Architectural Review Board Staff Report

Location: 633 S. Goddard Ave.

Description: **633 S. Goddard Ave. (Architectural Specialty Lighting Package):** An Architectural Specialty Lighting Package for a 5.50-acre tract of land zoned "M3" – Planned Industrial District, located on the west side of Goddard Avenue, south of its intersection with Chesterfield Airport Road.

Figure 2: Proposed Lighting Pole

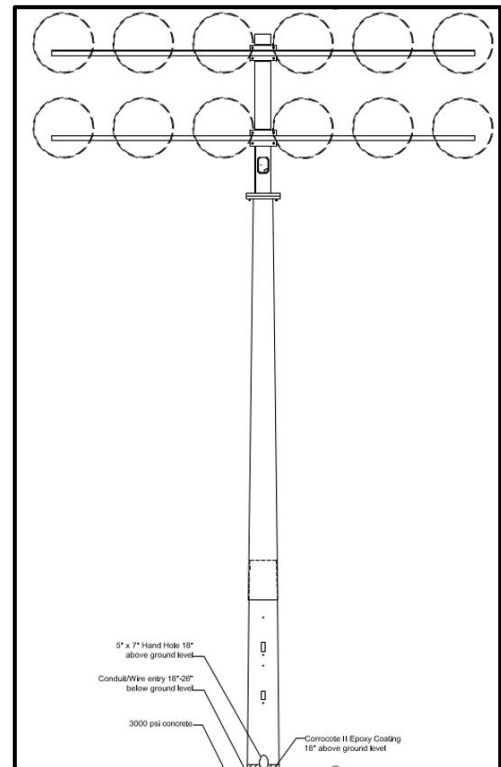
The maximum mounting height for all site lighting standards is twenty (20) feet. The applicant is requesting six (6) freestanding lighting poles with a mounting height of 76 feet each.

Code also states that all outdoor lighting for recreational facilities must be fully shielded to prevent light spillage and glare. The proposed fixture includes a partial shield to direct illumination on to the multi-purpose field. However, spillage onto an adjacent property is shown levels as 0 to 2 Fc, as indicated on the plan.

Legacy Performance Academy
 Chesterfield, MO
 50/30 Fc

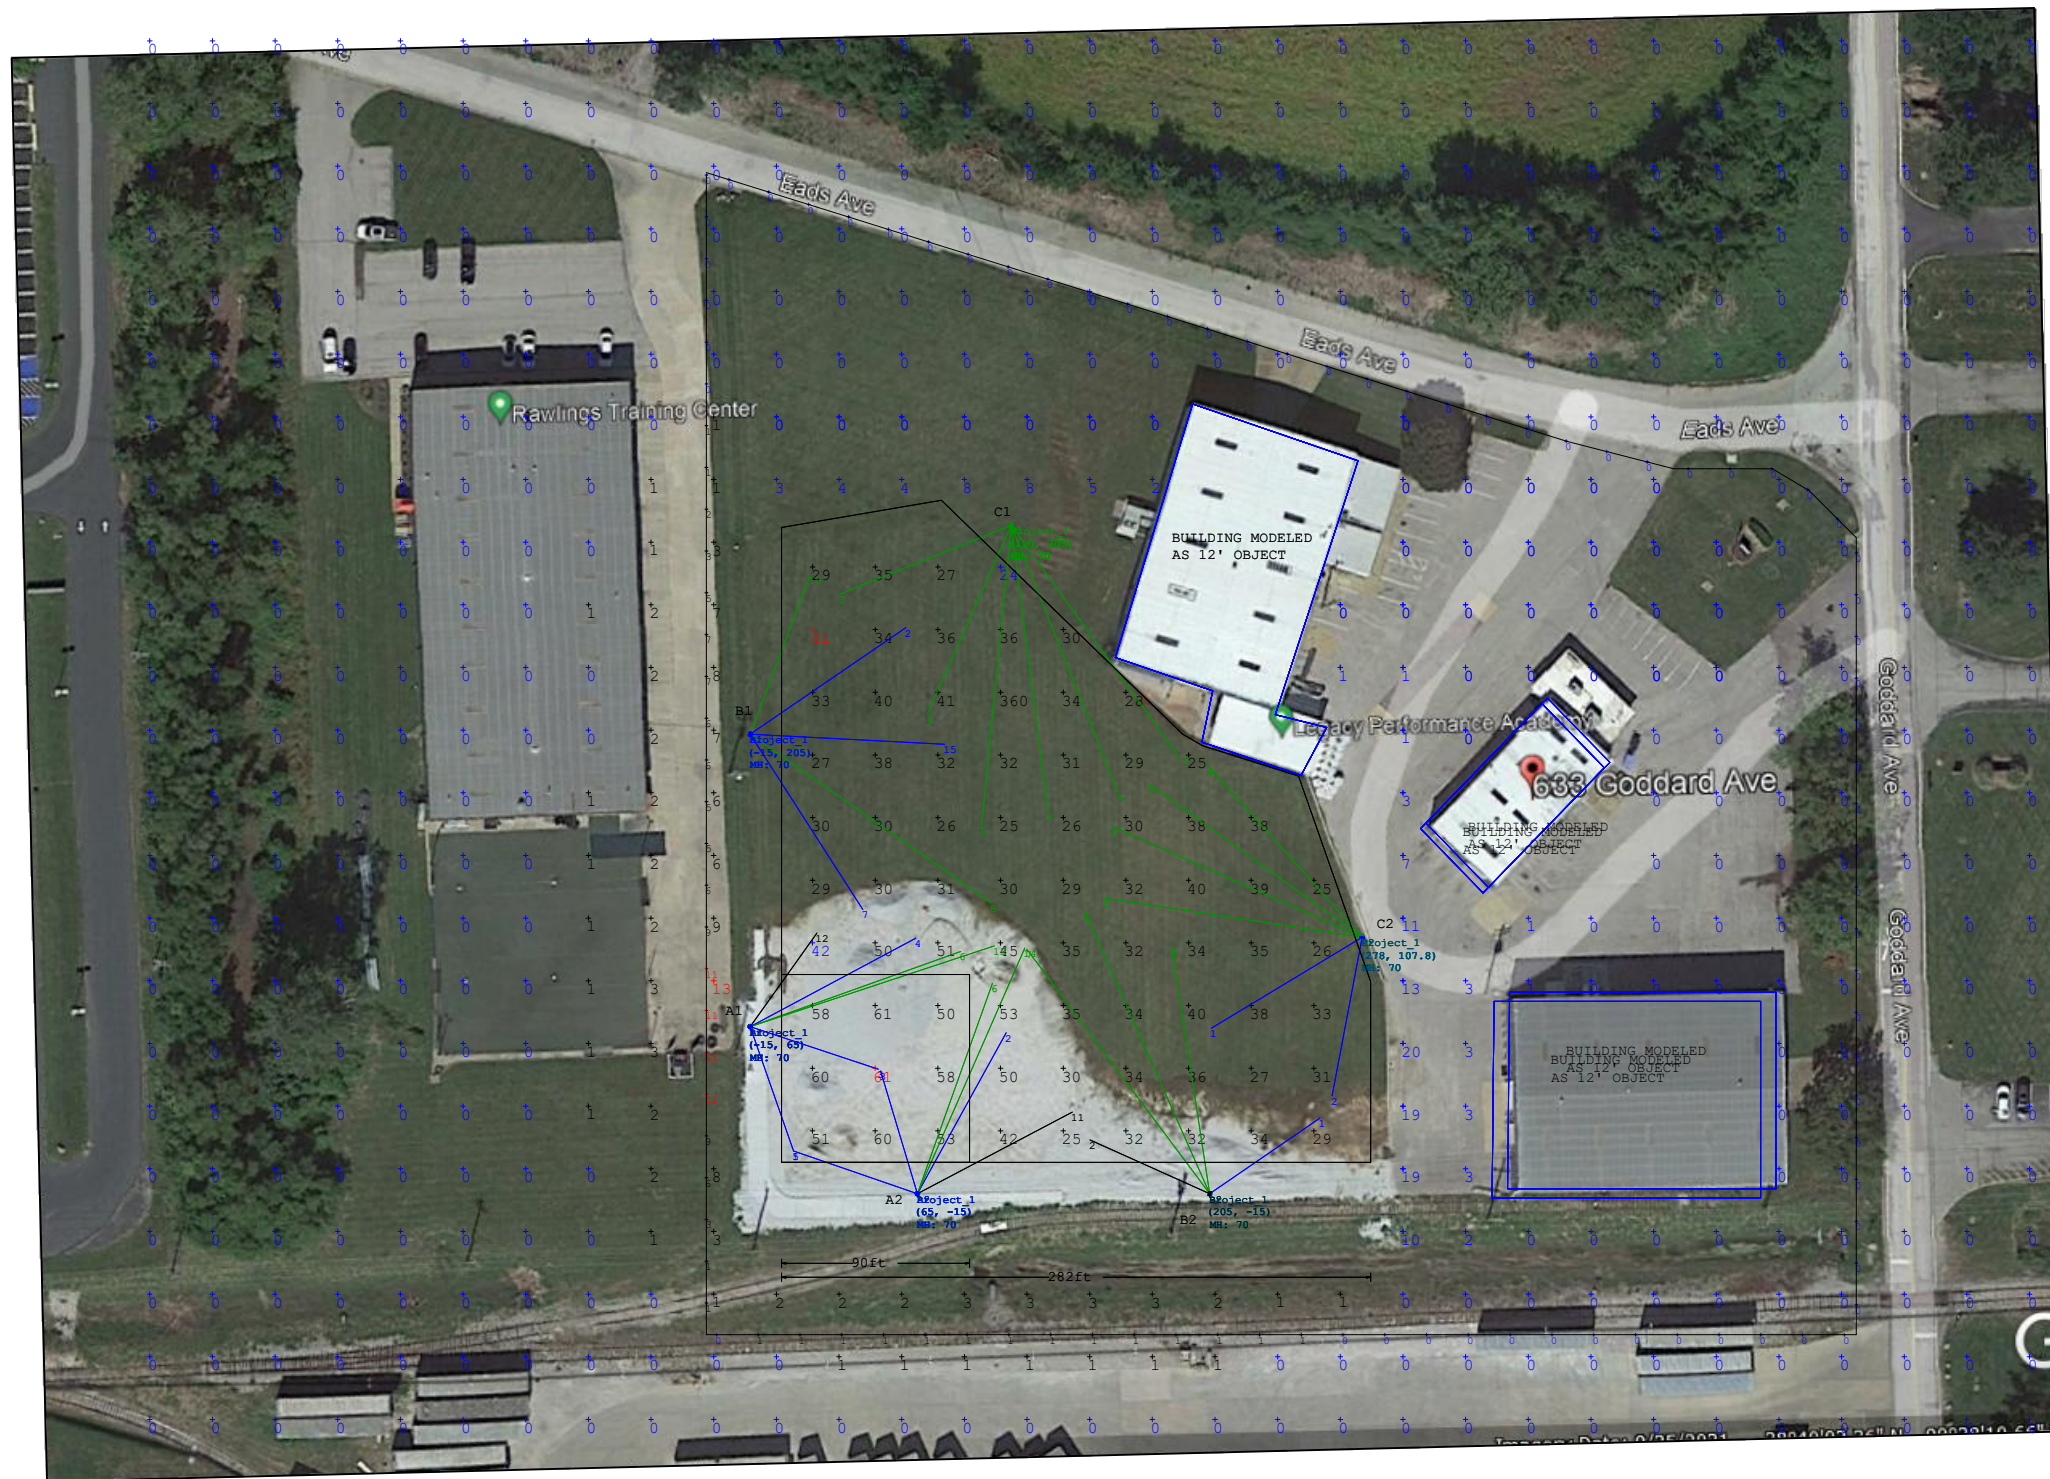
gas station canopies. The applicant is requesting an illumination level reaching maximum of 61 Fc in some areas of the plan.

- 1) With regards to mounting heights of lights, it is simply impossible to light most sports from only 20' off the ground. Especially sports in which a ball or object is often as high as 100' in the air. Pole heights for any sport are determined by the aiming angles required to reach all areas of the field uniformly, while also reducing glare. The IESNA standards (RP6) requires pole heights for multipurpose athletic fields to be a minimum of 70' above grade. Anything less than this is unsafe for players, coaches, and spectators at the site.

- 2) IESNA defines a Class III facility as a training facility with spectators, for up to an amateur or high school level of play. IESNA standards for a Class III field require the average maintained light level of the main field to be 50 footcandles with a uniformity ratio of 2.0:1 max/min or less. The outer portion of the playing area is required to maintain a 30 footcandle average at no greater than a 2.5:1 max/min uniformity ratio. While 8 FC of illumination is perfectly acceptable/normal in parking lots and other areas, which as I understand it is why that is the City Code, it would not make for a safe lighting situation
